**HUGHES
SERVICE INFORMATION
NOTICE**

NOTICE NO. N-140

SUBJECT: FIELD MODIFICATION - FUSELAGE FRAME ASSEMBLY

MODELS AFFECTED: All Model 269A/TH-55A/A-1/B Helicopters;
Model 269C Helicopter Serial No. 0004 thru 0539

Figure 1. Modification - Fuselage Frame Assembly
(Sheet 1 of 2)

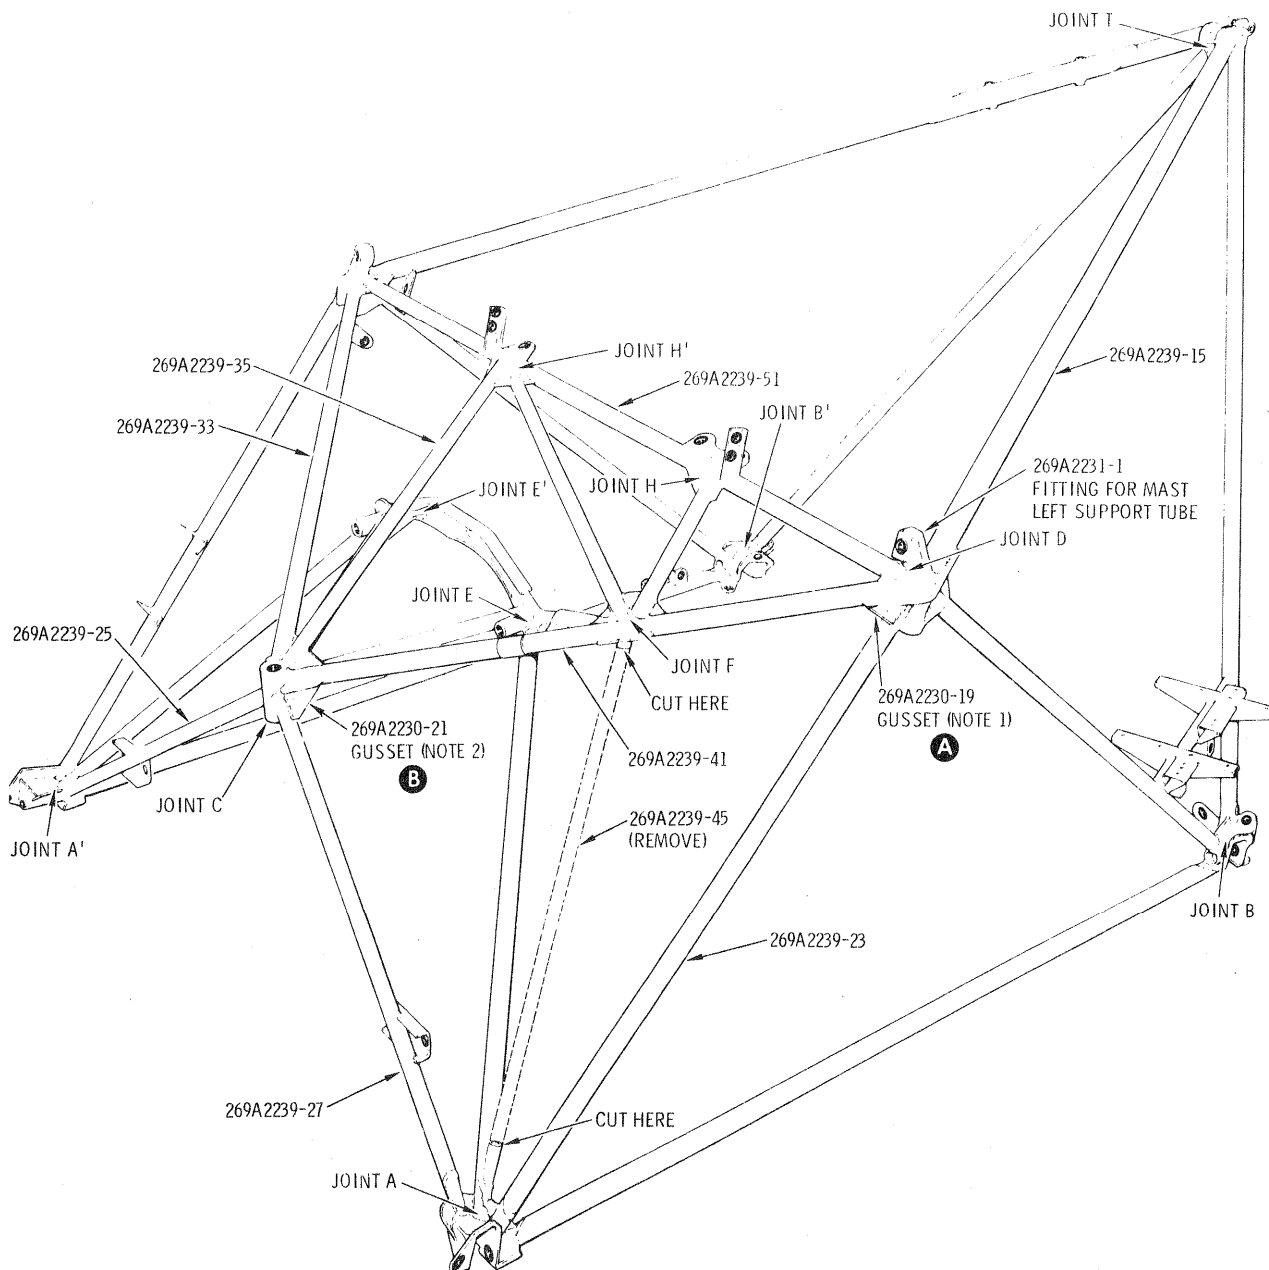
- a. Using metal cutting saw, remove 269A2239-45 vertical support frame tube as close as possible at Joint A and Joint F. (See Figure 1; also refer to Basic HMI for center frame section jig points.)
- b. Clean and treat exposed ends of tube and touch up with primer and paint for corrosion protection, per Section 2 of Basic HMI.
- c. Weld 269A2230-19 gusset in place at Joint D as shown in Figure 1; weld 269A2230-21 gusset in place at Joint C as shown. (Heliarc Welding Process preferred. Reference FAA AC 43.13-1A.)
- d. Prime and paint gussets as required, per Section 2 of Basic HMI.

1. GUSSET TO BE IN PLANE OF CENTERLINES OF 269A2239-41 AND 269A2239-23 FRAME TUBES.
2. GUSSET TO BE IN PLANE OF CENTERLINES OF 269A2239-41 AND 269A2239-27 FRAME TUBES.

Figure 1. Modification - Fuselage Frame Assembly
(Sheet 2 of 2)

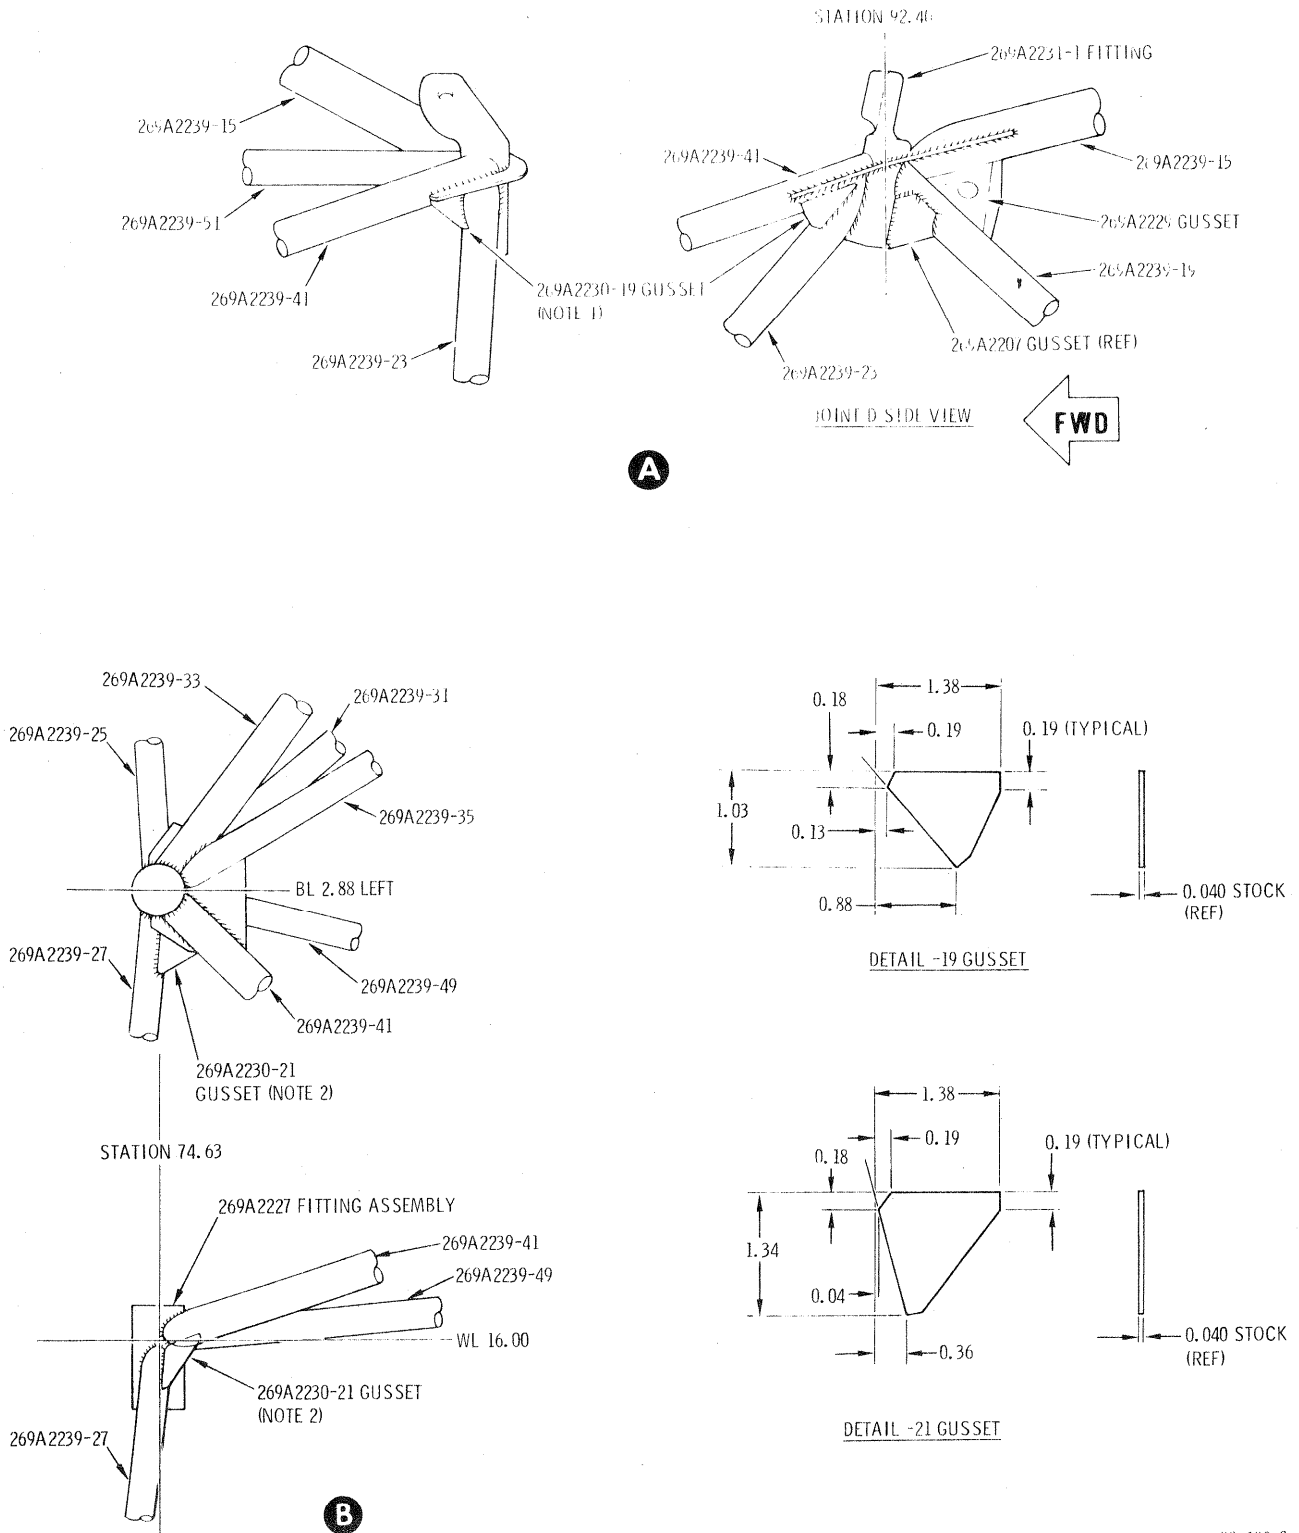
*See Figure 1, detail -19 and -21 for field fabrication
